NUCLEAR MANAGEMENT AND RESOURCES COUNCIL

November 21, 1989

This letter transmits NUMARC comments to DRAFT Generic Letter 89-XX, Station Blackout Response Submittals Analyses and Responses. Our comments are provided as Enclosure 1 and reiterate the similar positions expressed during the recent meetings with you and members of your staff.

## Final NUMARC Comments on Draft Generic Letter

FIGURE A (Acceptable)

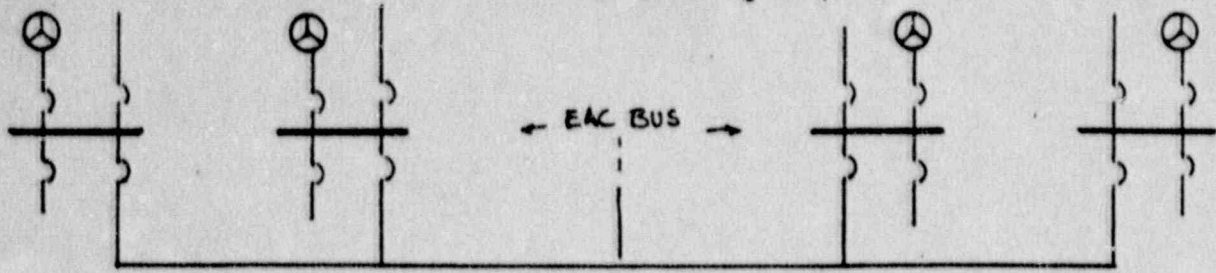
Example 1. A single cross-tie connected to either of two EAC sources is acceptable. Figures A and B, Attachment 1, show two such cross-tie configurations, although acceptable configurations are not limited to these examples. In this case, a single failure of one EAC source does not prevent use of the second EAC source for AAC power.

FIGURE C (Unacceptable)

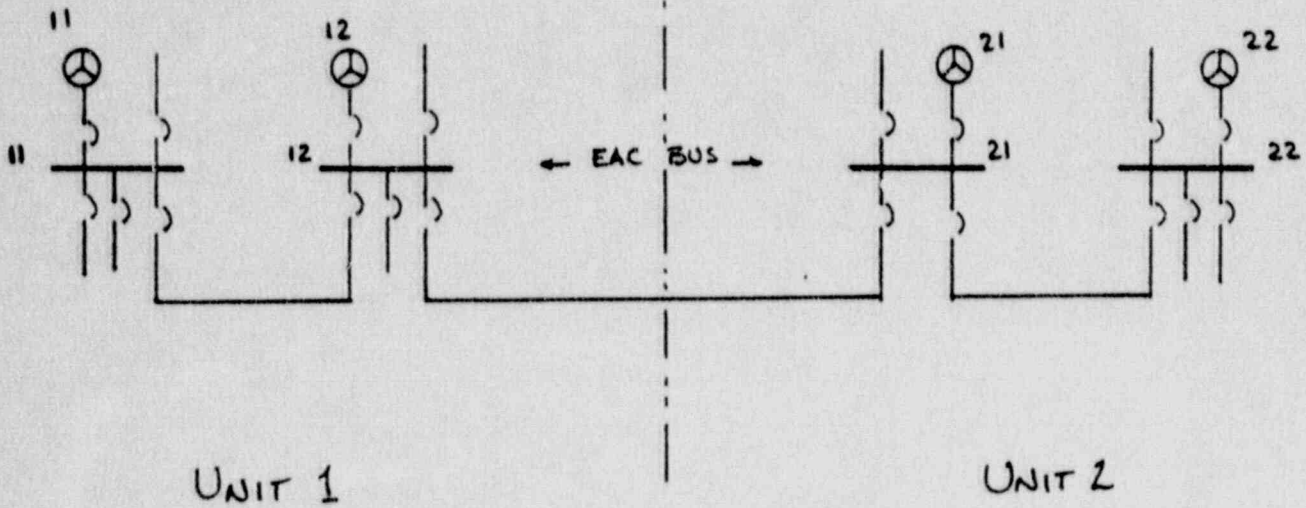
Example 2. Figure C, attached, illustrates a potentially unacceptable single cross-tie connecting one EAC source to a second EAC source, and then connecting the second EAC source to the blacked-out unit.

In Figure C, assume Unit 1 is the blacked-out unit. Thus, diesels 11 and 12 are not available, and either diesel 21 or 22 is assumed to fail per the EDG single failure. The remaining diesel (21 or 22) may be designated as an AAC source provided Appendix B criteria are satisfied. However, a single active failure of Bus 21 would violate Criterion B.8.e regardless of which EAC source (21 or 22) is the AAC source.
